Capacity Market Advisory Group (CMAG) Briefing

Date	2 December 2024	Classification	Public
CP or Subject	CP373 Audit follow-up Surgery Items and Housekeeping	Document version	Draft

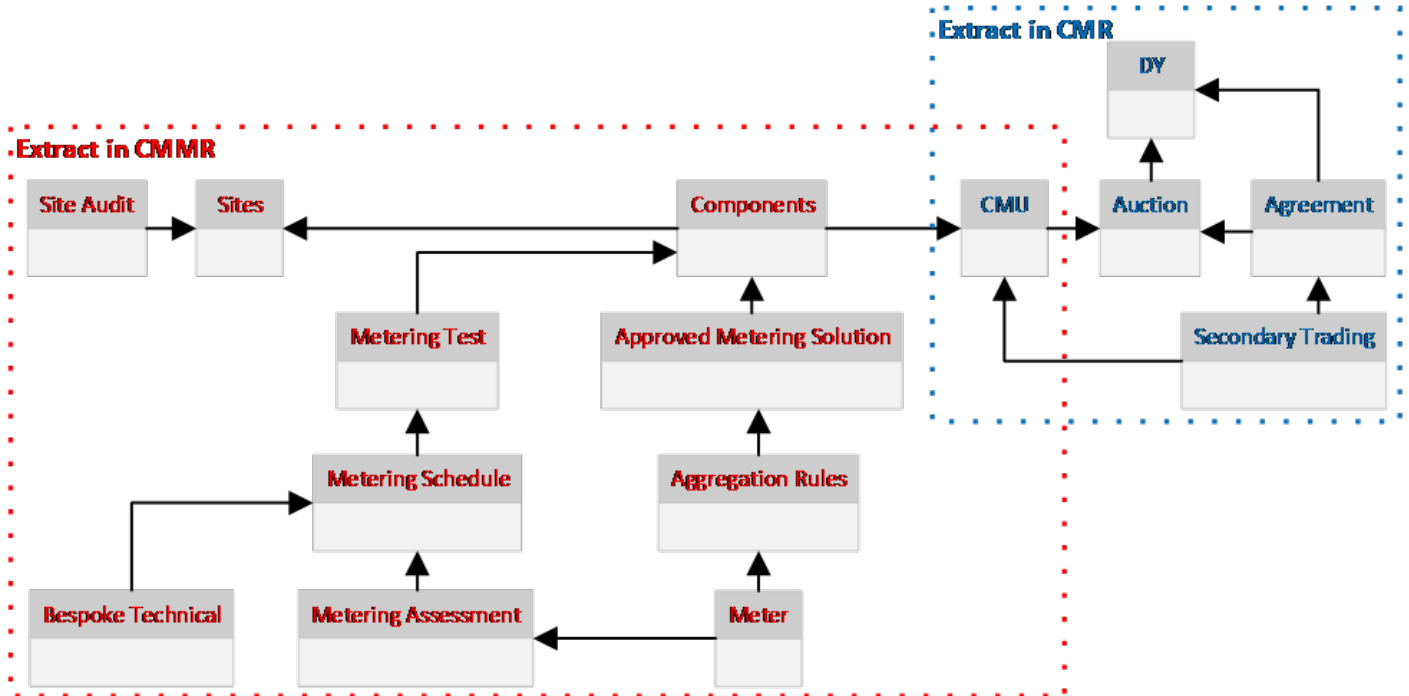
Note that these files are published as CSV files and therefore are NOT formatted in any way. This inevitably makes them much more difficult to use by a third party who wishes to do more than just access their own metering information via My EMRS. This leads to specific problems when loading such files in Excel, eg

- Header row not formatted
- Freeze panes not set
- Data Filter not set
- Numeric MEIDs
 - starting with 0 dropping that 0, and
 - those that do not start with 0 being displayed as large numbers (eg 1.47E+12 instead of '1470000473765')

Should this be raised as a Surgery Item at CMAG?
